RE: **Lot 31 Block 8 Unit 5 SAD 227**  
**7908 Marigold Dr NW**  
**Volcano Cliffs Subdivision**  
**Grading and Drainage Plan**  
**Engineers Stamp Date 1/8/2026 (E10D133)**  
**Case #: HYDR-2026-00004**

Based upon the information provided in your submittal received 1/8/2026, this plan is approved for Grading Permit.

ZEMKE - FELLOWSHIP HOMES - G & D PLAN

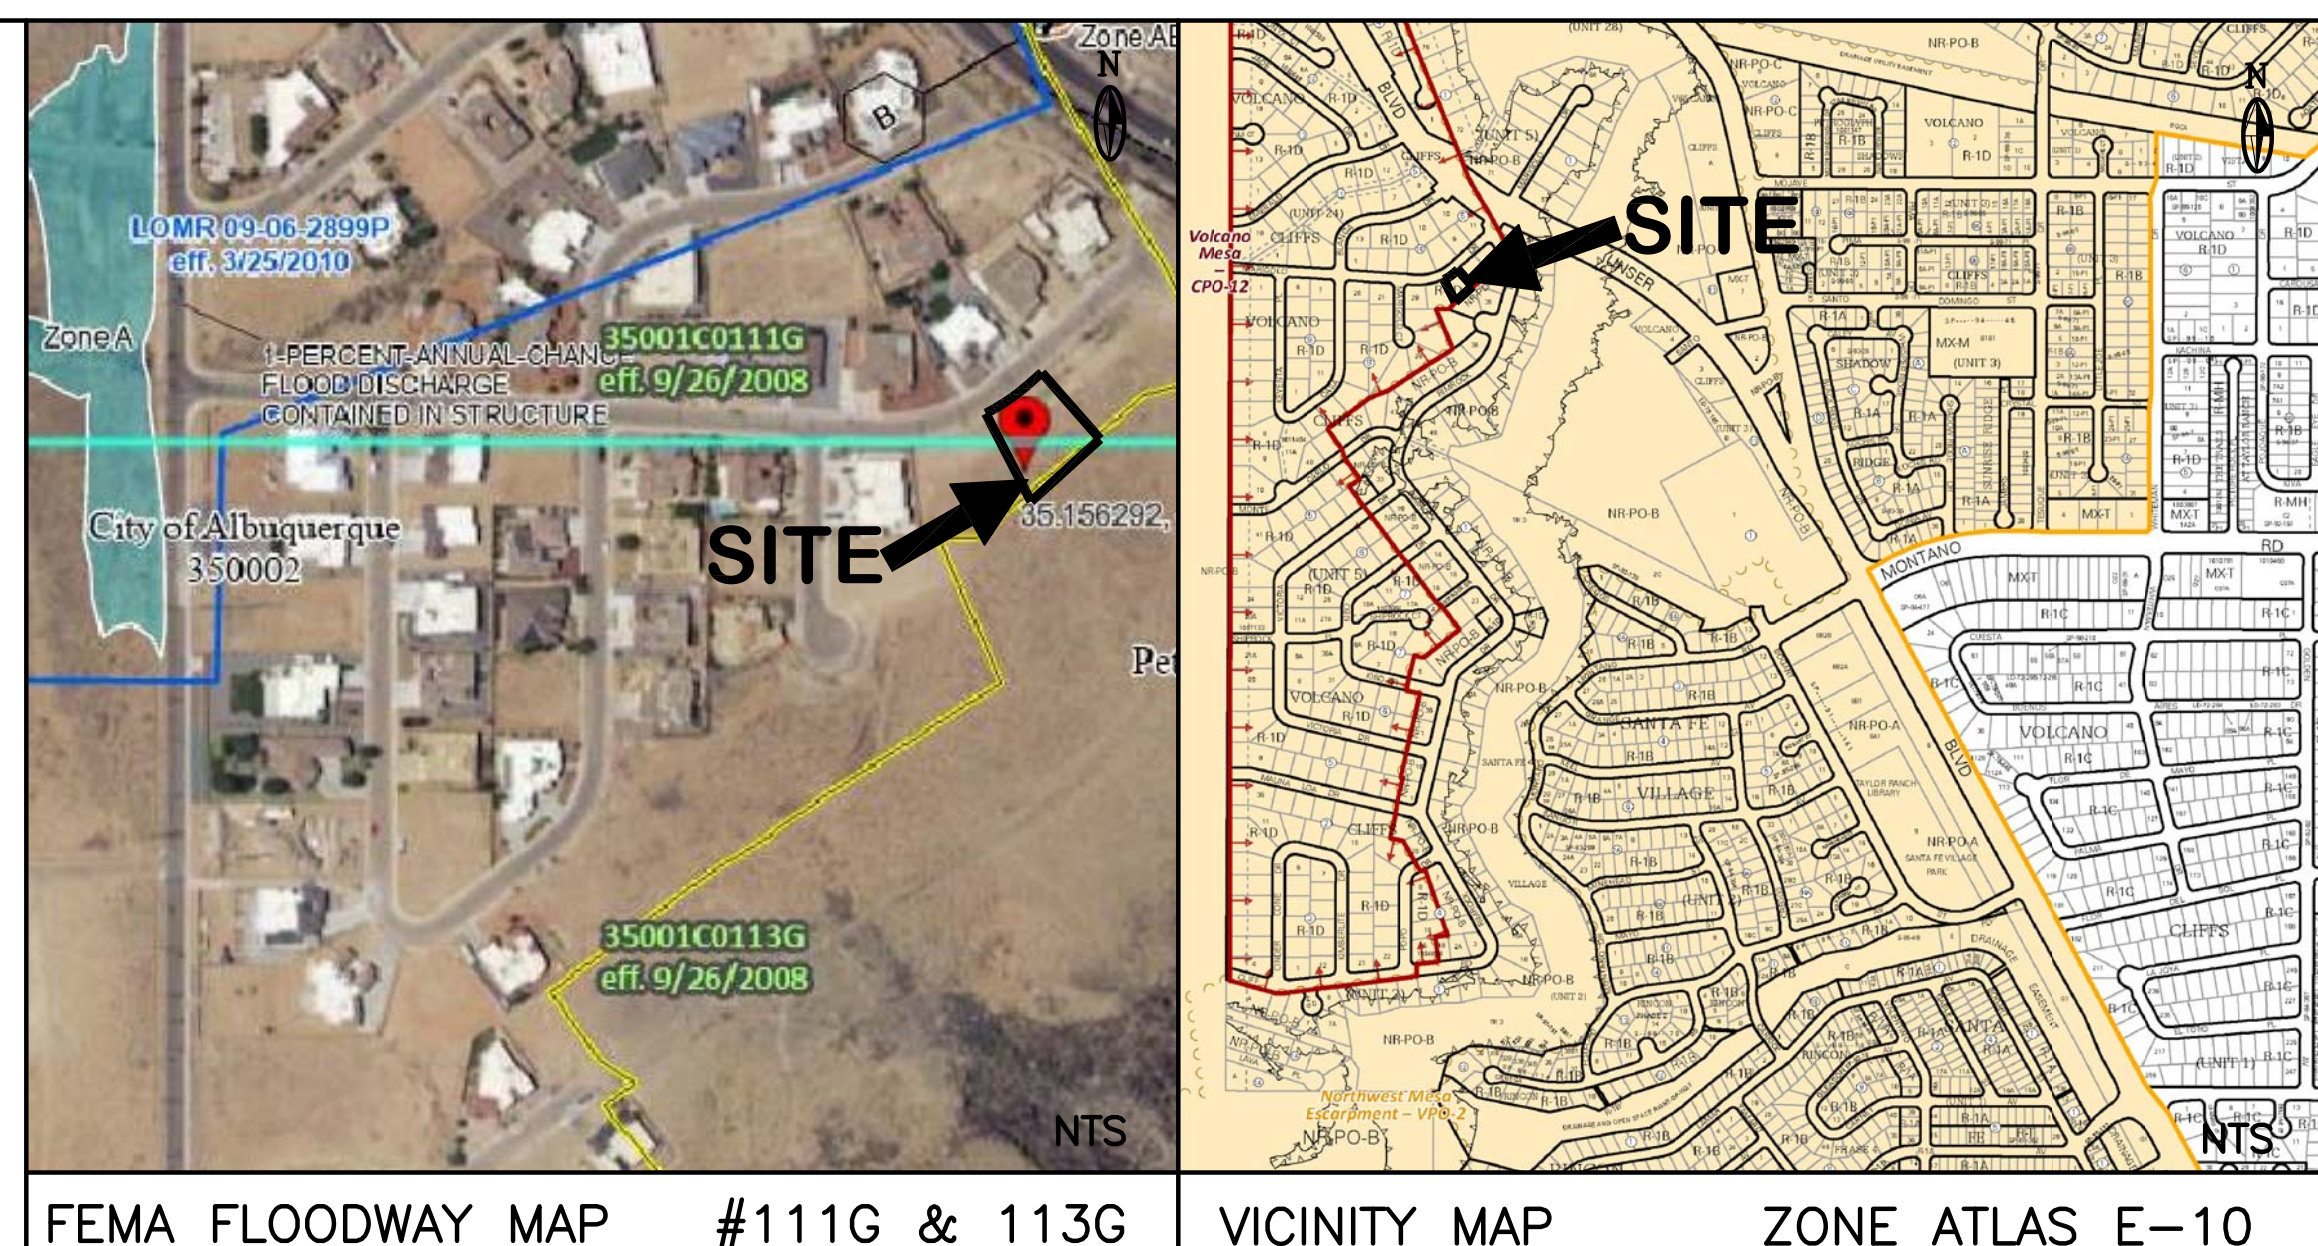
**Prior to Building permit approval, a Pad Certification will be required, provided by the Engineer or a registered Land Surveyor.**

**Advise the owner's contractor not to use dirt as a ramp to climb the curb, use lumber or crusher fines for this purpose. Place this note on the plan.**

Reiterate to the Owner/Contractor that a separate permit for a garden/retaining wall must be obtained with the approved G&D plan and Pad Certification. Also, if a swimming pool is to be placed after this approval a new grading and drainage plan will need to be resubmitted showing the changes for the land treatments.

**Prior to Certificate of Occupancy release, Engineer Certification per the DPM checklist is required.**
